1130A-01B

1130A Infiniimax Probe Amplifier 1.5GHz

Possible fractured solder joint on input pin

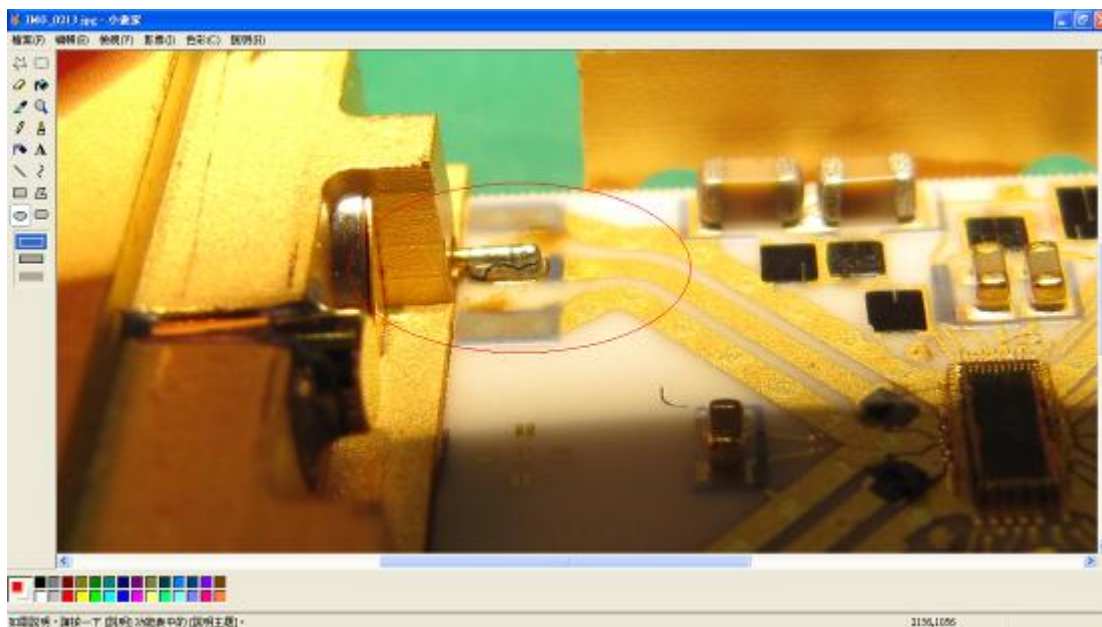
The above picture shows a fractured solder joint.

The above picture shows where the long pin of the probe amplifier actually got stuck in the female connector of the probe head. When the probe head was removed from the probe amp, part of the probe head female connector stuck to the probe amplifier pin and was pulled out.

5. If you determine that the solder joint is fractured, bent, broken, or probe head parts stuck to a probe pin, replace with a new 01130-68701 probe amplifier. Charge the replacement cost to factory warranty.

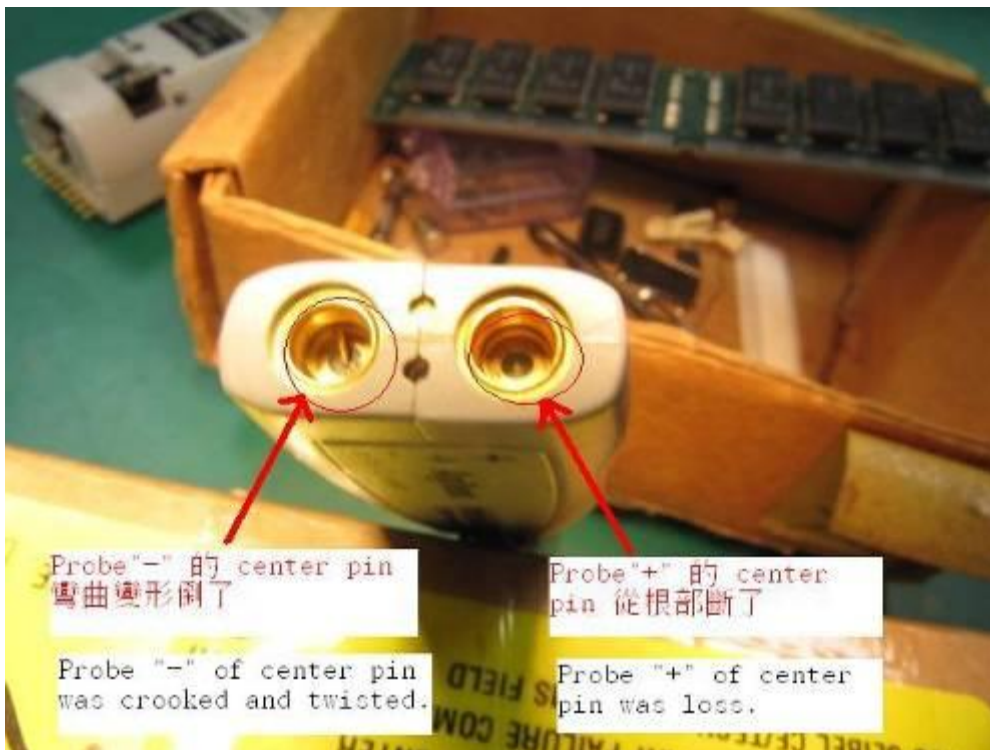
The above picture shows a bent male pin and a broken male pin. The longer male pin could cause the pin to bend or eventually break when connected to a probe head.

If you find the above mechanical defects, replace with a new 01130-68701 probe amplifier.
